**AGENDA**  
**City of Gig Harbor Design Review Board**  
**Virtual Meeting of May 27, 2021 at 5:00 pm**

## Staff Memorandum

SUBJECT: Mallards Landing Lot 7: Assisted Living Facility (PL-DR-19-0021)  
**Public Meeting Date: May 27, 2021**

Fixture A & D

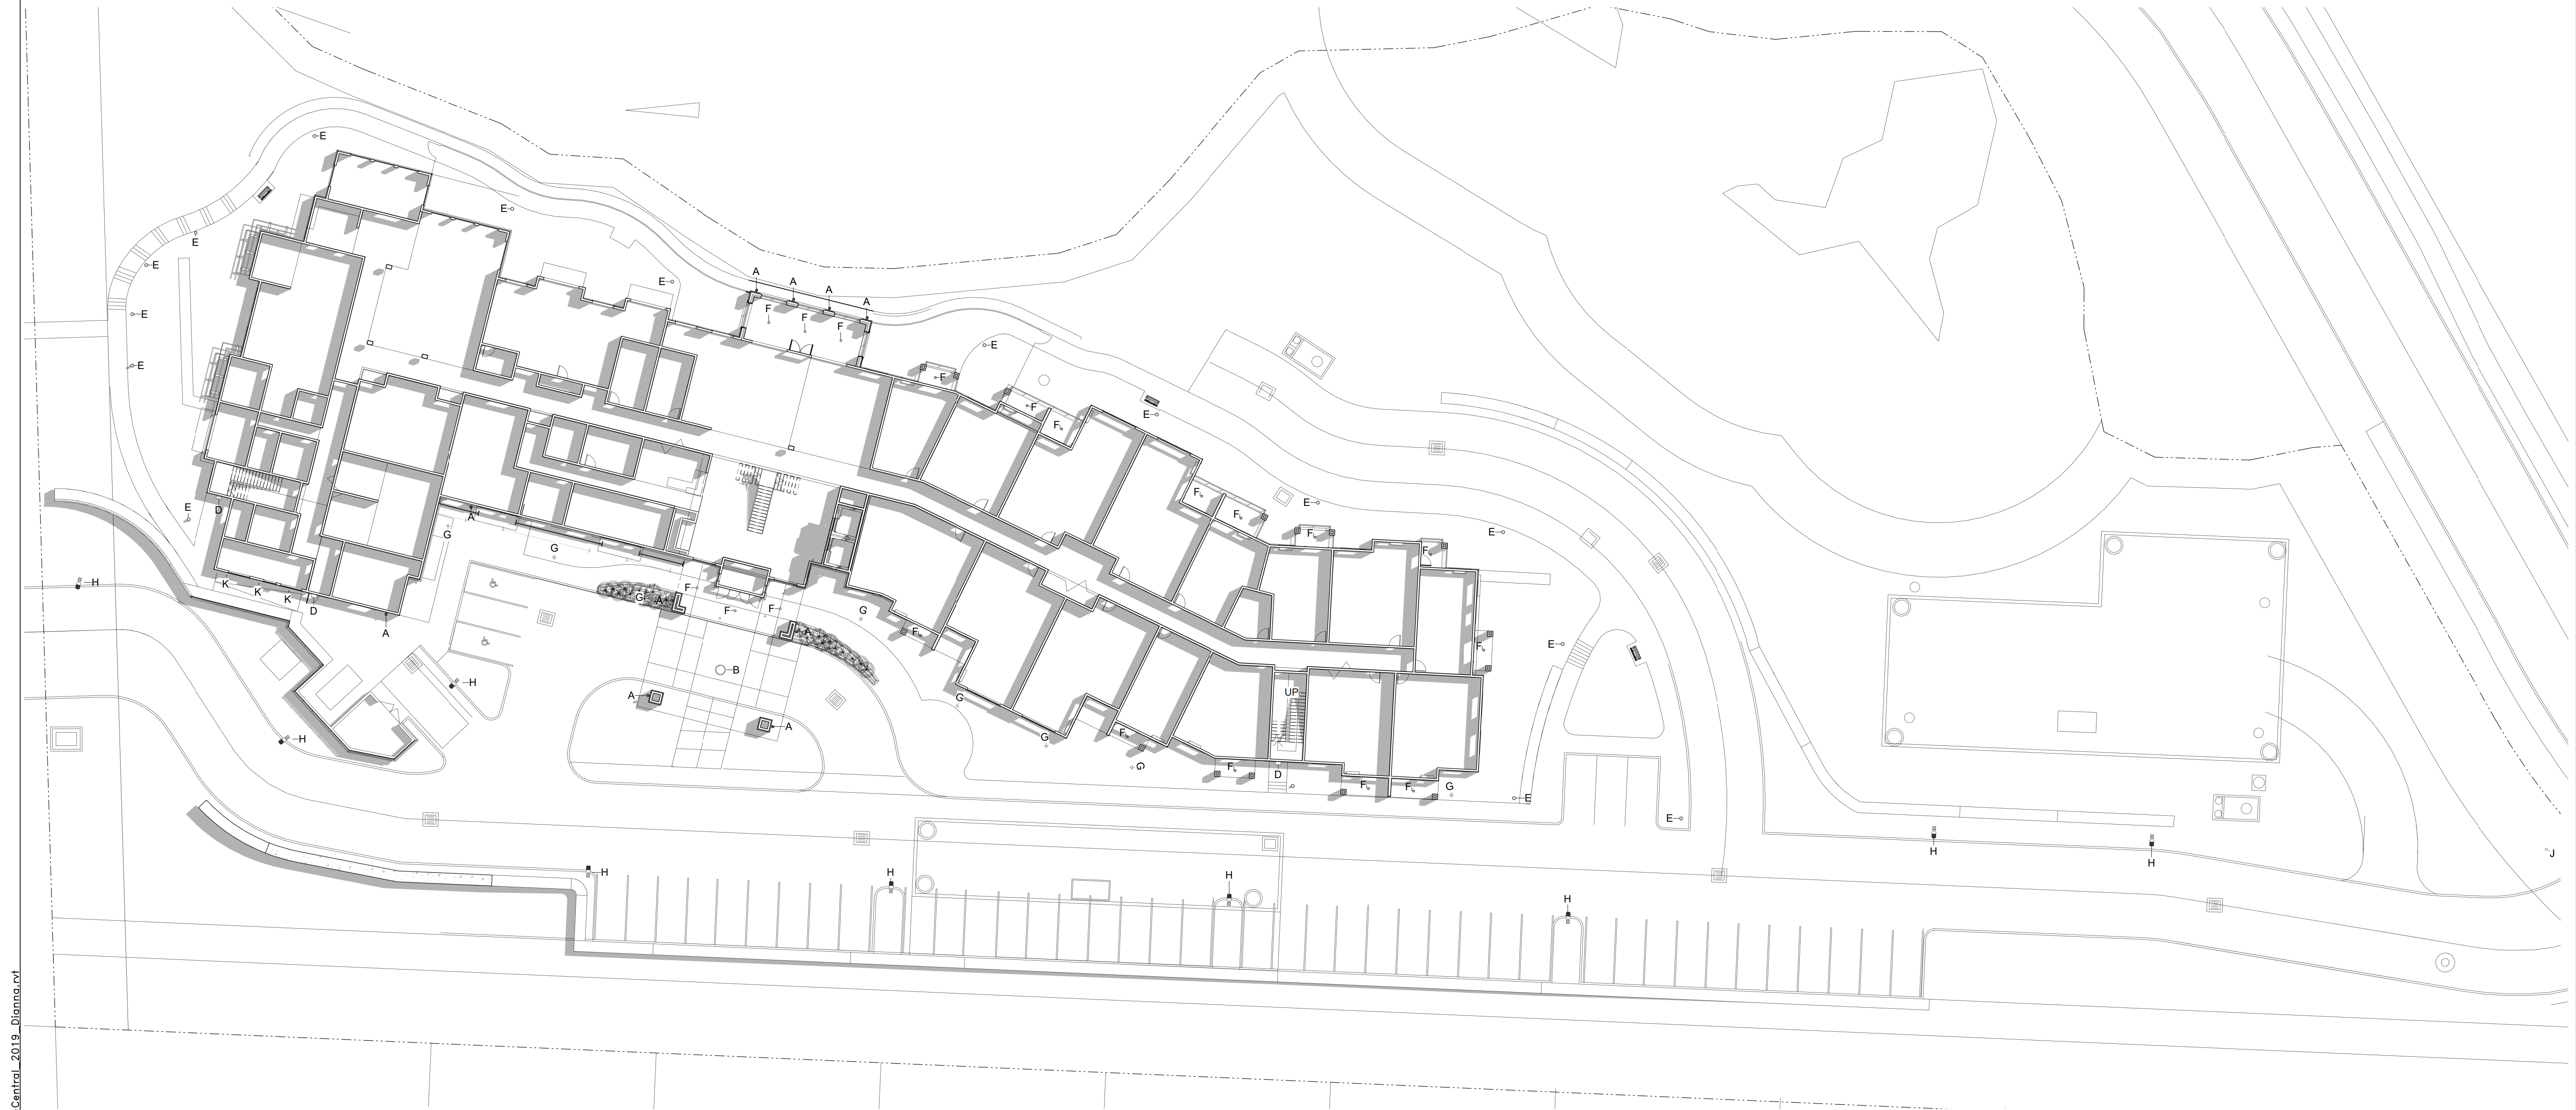
For design element F, the applicant has provided a lighting plan. The plan can be found on Exhibit E, Sheet A07. The plan does not include a photometric, nor does it include pole heights. Staff would note that, in addition to the following comments, the applicant will need to provide a photometric plan, pole and wall heights for parking/pedestrian fixtures and sconces, respectively.

- Fixtures A & D: If mounted above 7-feet, the lighting shall be downward directional. Further, the Tallman Annexation Concomitant Zoning Agreement prohibits light projection above the horizontal plane between midnight and sunrise. Lastly, GHMC 17.99.460 requires that outdoor building lighting is limited to one 60-watt bulb, or equivalent foot candles, on any 10-feet of façade length; except at building entrances.

**PERSPECTIVES**

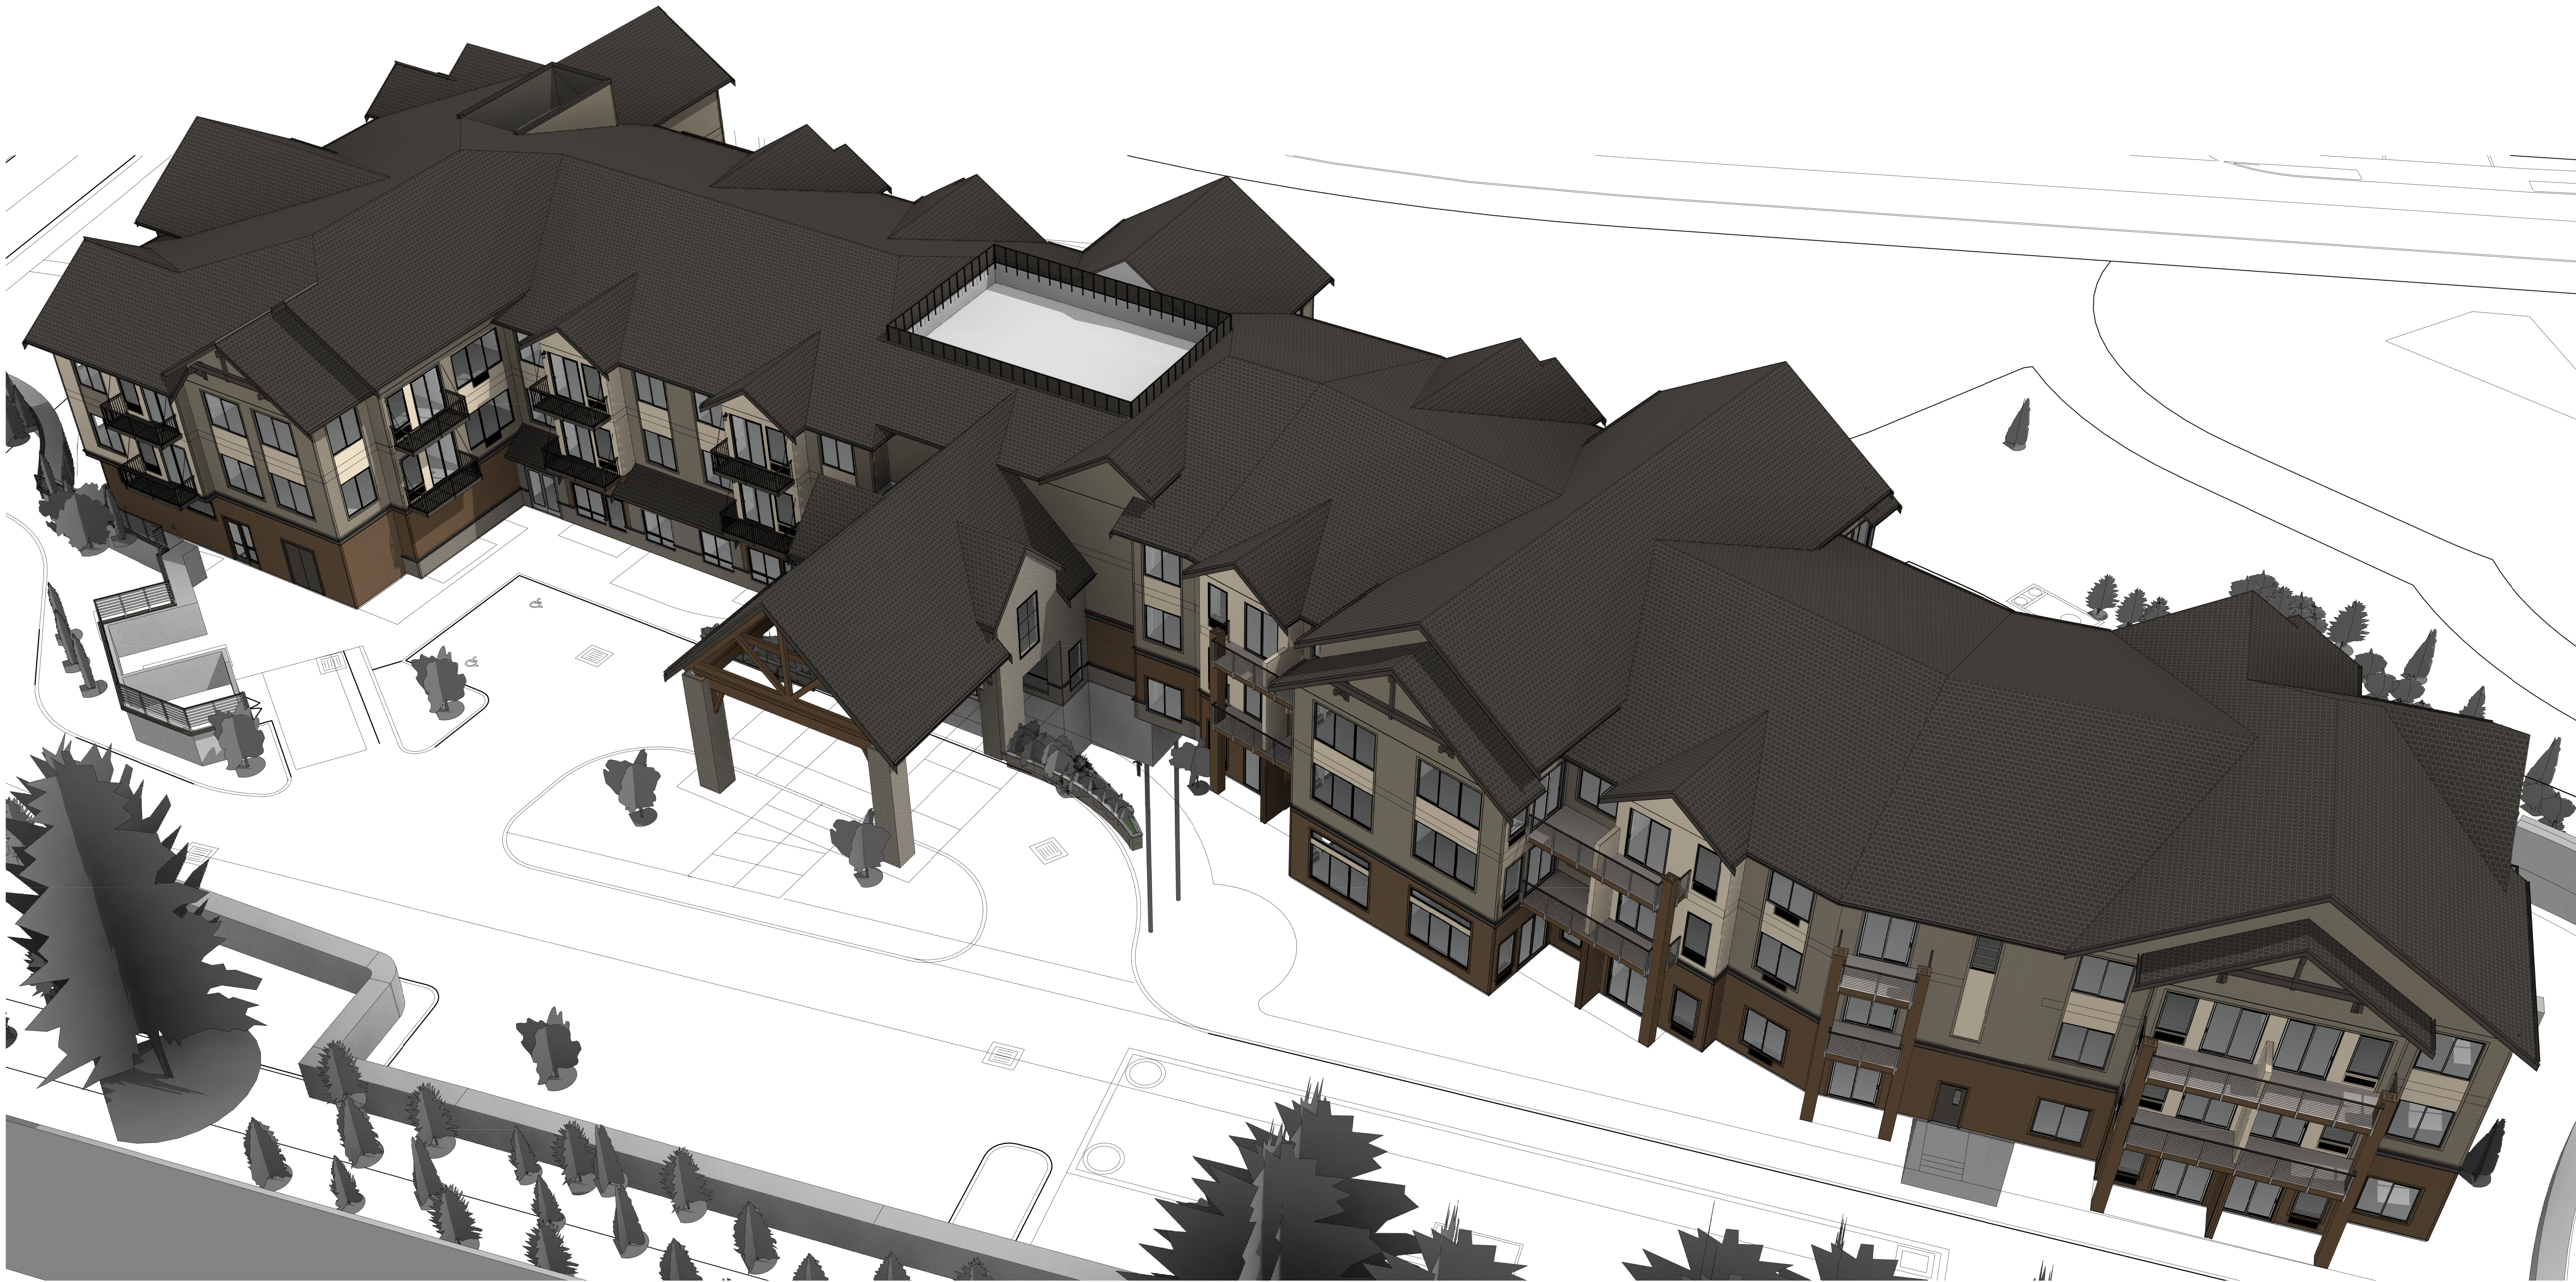
Both options add additional landscaping around the service area to better screen it from view. The applicant has also provided additional renderings of the building's entranceway and service area to show views from the drive aisle (see Exhibit E, Sheet A19).
